Access Compliance Report Public Rights-of-Way (Curb Ramps)

Main Street: N/A		Cross Street: ORTEGA_HWY		Location:	S
ADA ID: RPRK211122140627	Ramp Type:Type 1 - Perpendicular	Initial Pass/Fail: Fail	Overall Compliance: No	Severity Score:	2
Codes/Mitigation Info/Possible Solution			Field Measurements/Component Compliance

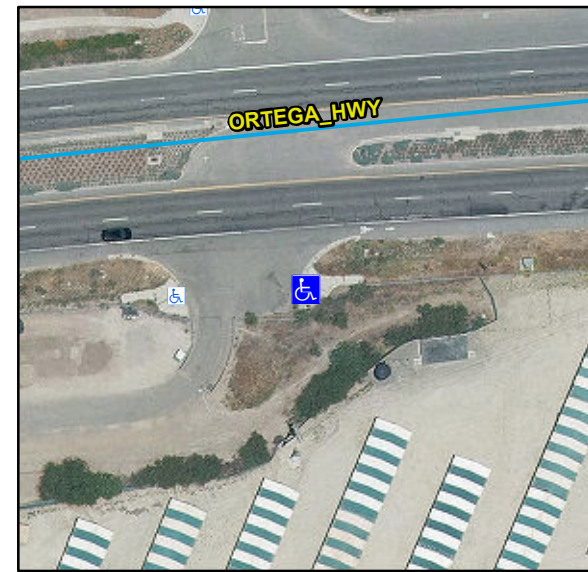
R304.2.2, R304.5.3, STD 1115

Compliance	Description	Data	Compliance	Description	Data
N/A	Ramp Length (in)	120	N/A	Flare Type LT	
Yes	Ramp Width (in)	48			N/A
Yes	Ramp Run Slope (%)	7.8	N/A	Flare Slope LT (%)	N/A
No	Ramp Cross Slope (%)	2.8	N/A	Flare Traversable LT	N/A
N/A	Landing Present	N/A	N/A	Flare Type RT	
N/A	Landing Length (in)	N/A			N/A
N/A	Landing Width (in)	N/A	N/A	Flare Slope RT (%)	N/A
N/A	Landing Run Slope (%)	N/A	N/A	Flare Traversable RT	N/A
N/A	Landing Cross Slope (%)	N/A	N/A	DWS Provided	N/A
N/A	Landing Movement Obstructed?	N/A	N/A	DWS Contrast	N/A
	Landing Movement Type	N/A	N/A	DWS Length (in)	N/A
N/A	Landing Shared	N/A	N/A	DWS Full Width	N/A
N/A	Clear Space	N/A	N/A	DWS Offset Left (in)	N/A
N/A	Clear Space To Crosswalk (in)	N/A	N/A	DWS Offset Right (in)	N/A
N/A	Marked Crosswalk 1	No	N/A	Marked Crosswalk 2	N/A
	Crossing 1 Direction	W		Crossing 2 Direction	N/A
	Marked Crosswalk 1 Width (in)	N/A		Marked Crosswalk 2 Width (in)	N/A

N/A	Ramp Inside Crosswalk 1	N/A	Yes	Ramp Inside Crosswalk 2	N/A
	Crossing 1 Slope (%)	6.6		Crossing 2 Slope (%)	N/A
	Crossing 1 Cross Slope (%)	2.8		Crossing 2 Cross Slope (%)	N/A
N/A	Gutter Ponding	N/A	No	Curb Slope	9.5
Yes	Gutter Lip Height (in)	0		Road Run Slope (%)	N/A
N/A	Gutter Run Slope (%)	N/A		Road Cross Slope (%)	N/A
N/A	Gutter Cross Slope (%)	N/A			
Yes	Overall Surface Condition: Acceptable		Yes	Perp Joint Present	Yes
	Cross Gutter Present?	No		Spandrel Present?	No
	Replace Cross Gutter?	N/A		Replace Spandrel?	N/A

Remove & Replace Entire Ramp.
